JADE PARK

PLAY AREA RENOVATION

RECORD DRAWINGS SEPTEMBER, 2009

This set of Record Documents consists of corrected plans showing the reported location of the work, conforming to the construction records provided by the Contractor. While the information submitted by the Contractor and incorporated by the Landscape Architect into the Record Documents is assumed to be reliable, the Landscape Architect has not verified the accuracy and/or completeness of the information and shall not be responsible for any errors or omissions which may be incorporated herein as a result. Those relying on these Record Documents are advised to obtain independent verification of their accuracy before applying it for any purpose.

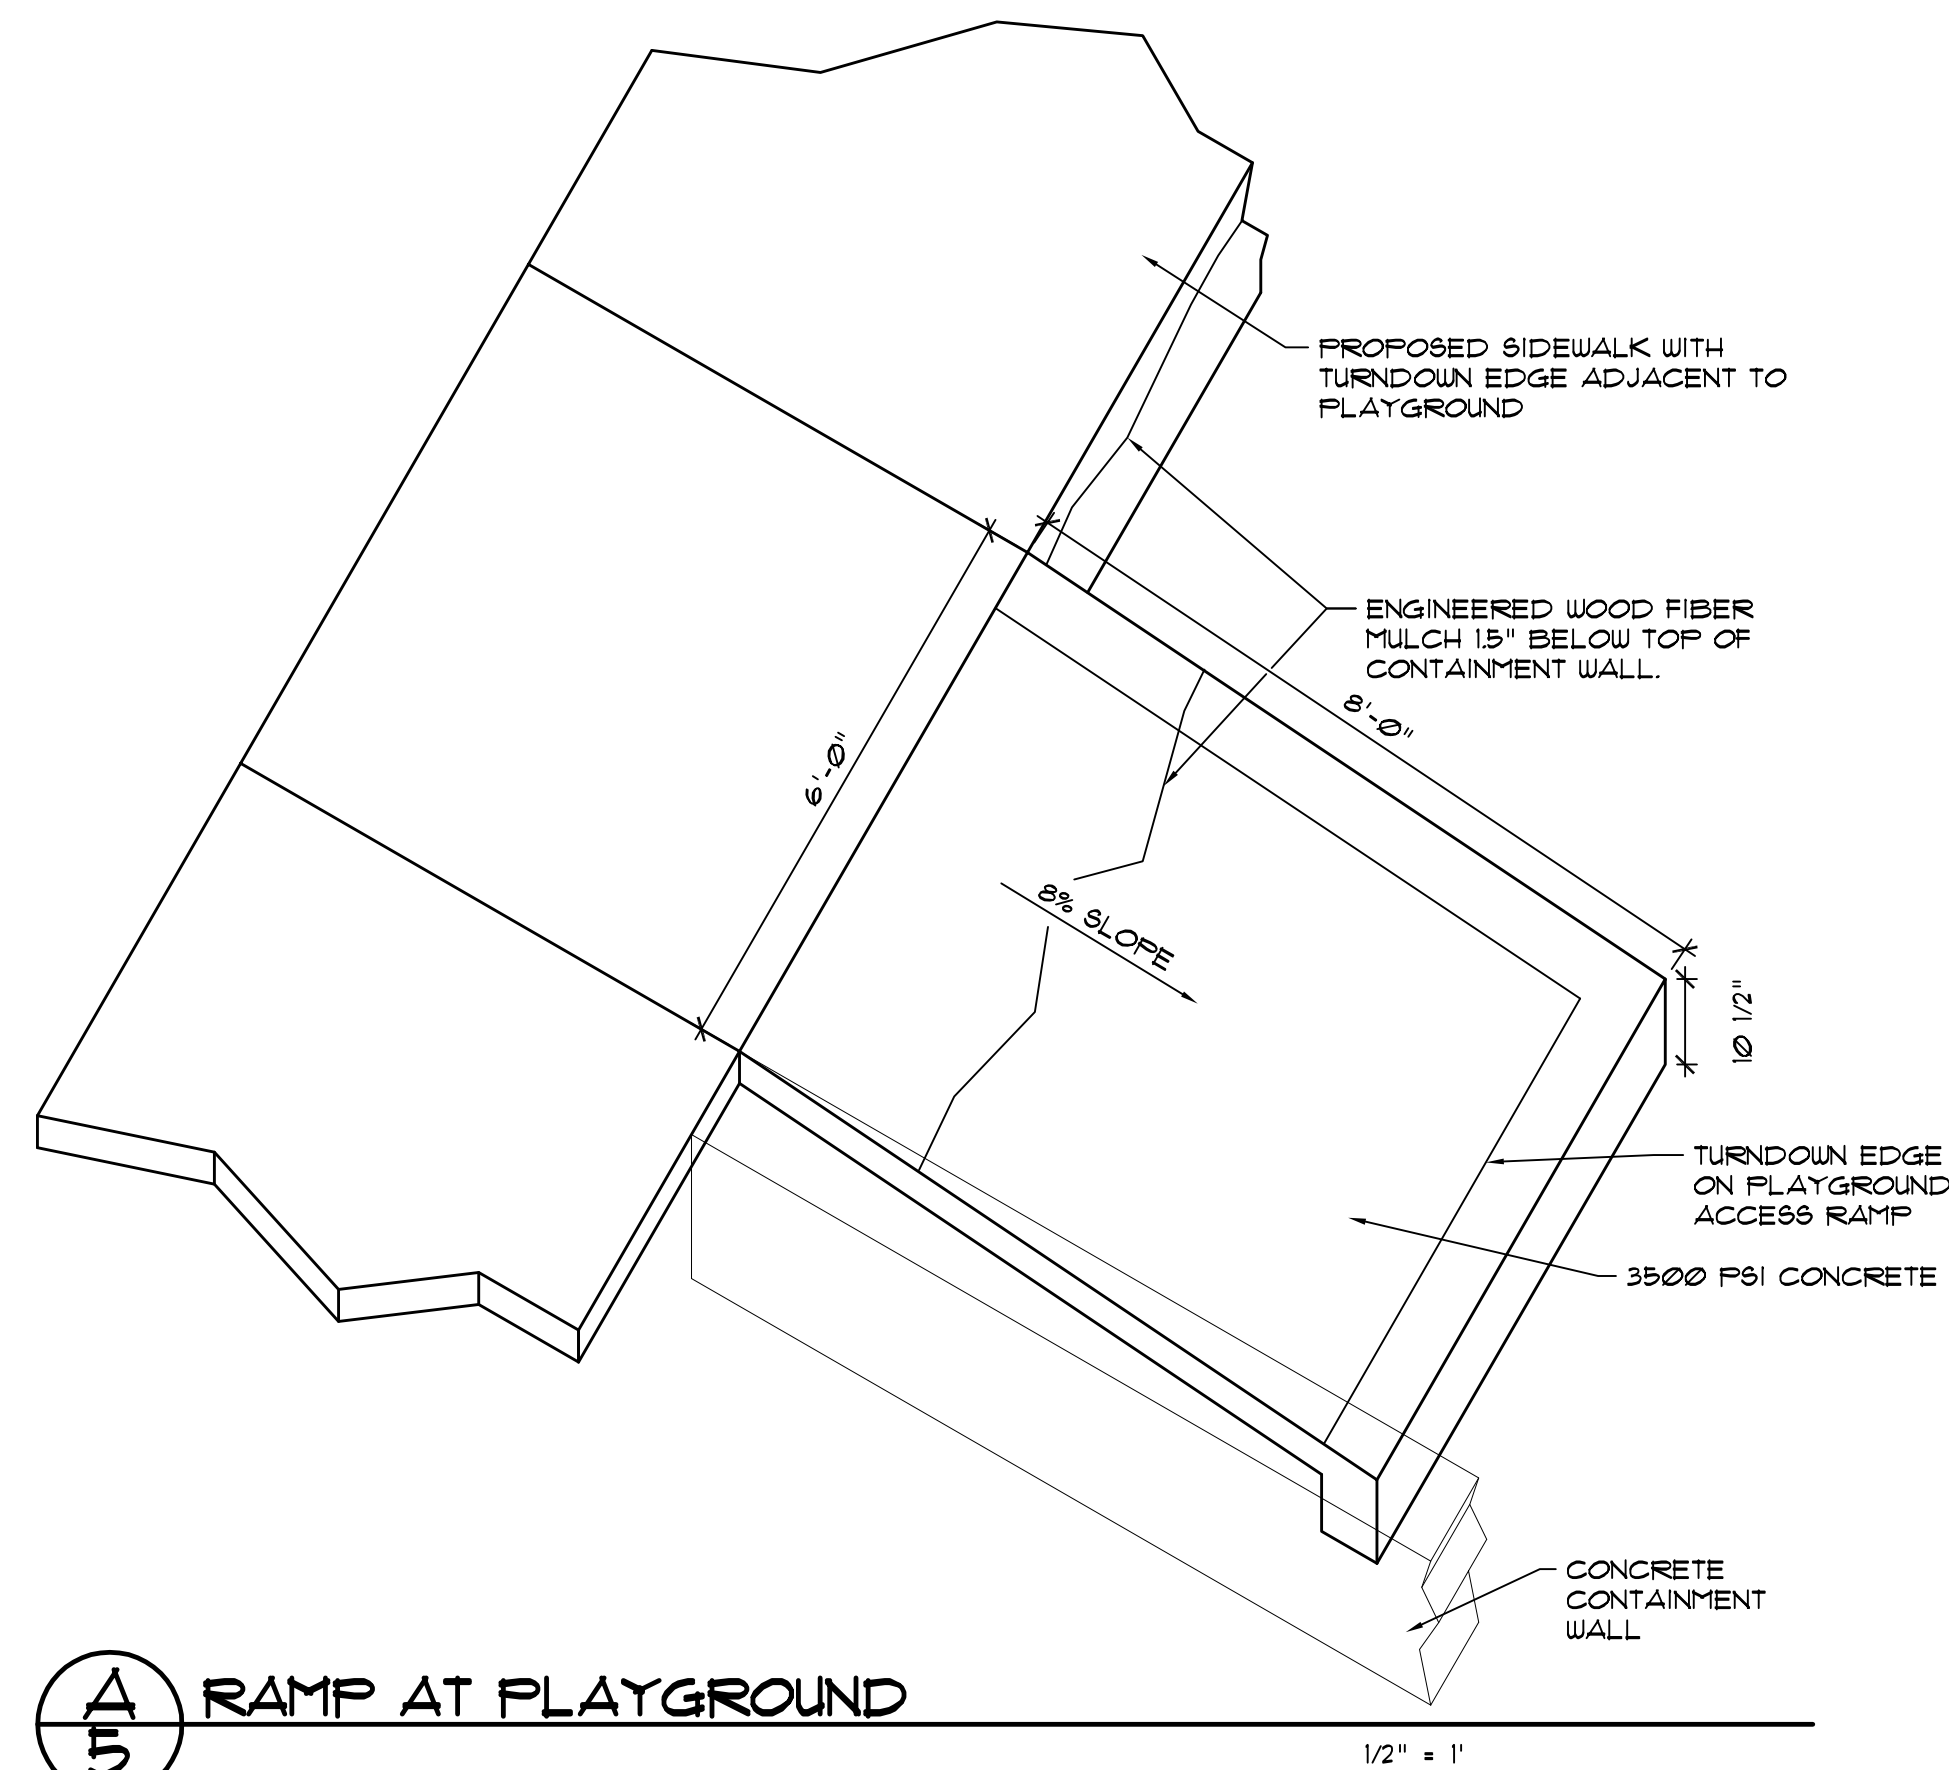
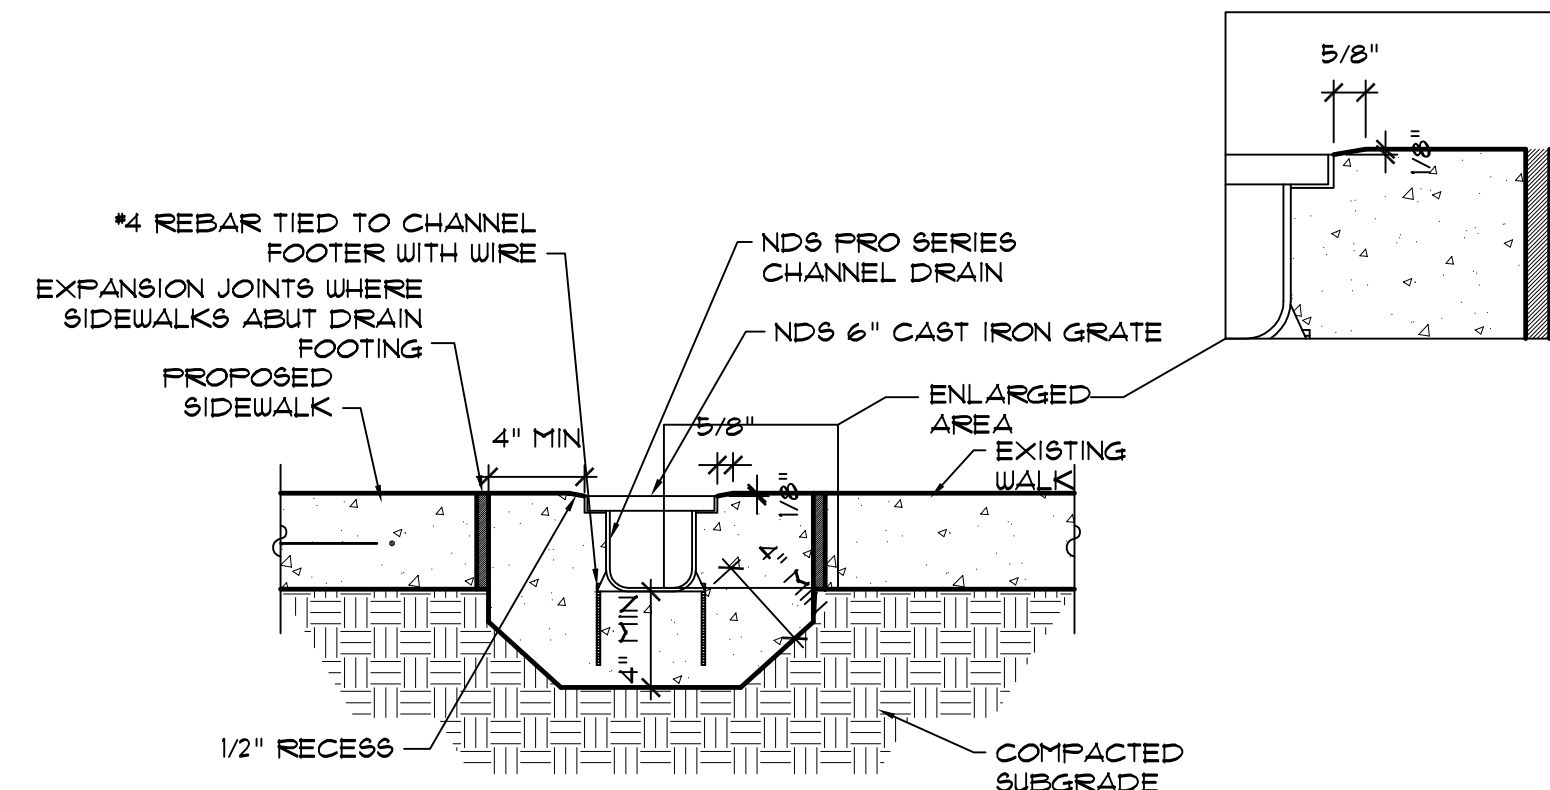
AT THE DATE OF PREPARATION OF THESE RECORD DRAWINGS,
PHASE II HAS NOT BEEN BUILT.

1. CONCRETE WALK SHALL HAVE A 2% CROSS SLOPE FOLLOWING DIRECTION OF EXISTING GRADE.
2. IF PHASE 2 IS ACCEPTED, CONTRACTOR SHALL DEMO ~~CONCRETE CONTAINMENT WALL ALONG NORTH SIDE OF PLAY AREA~~
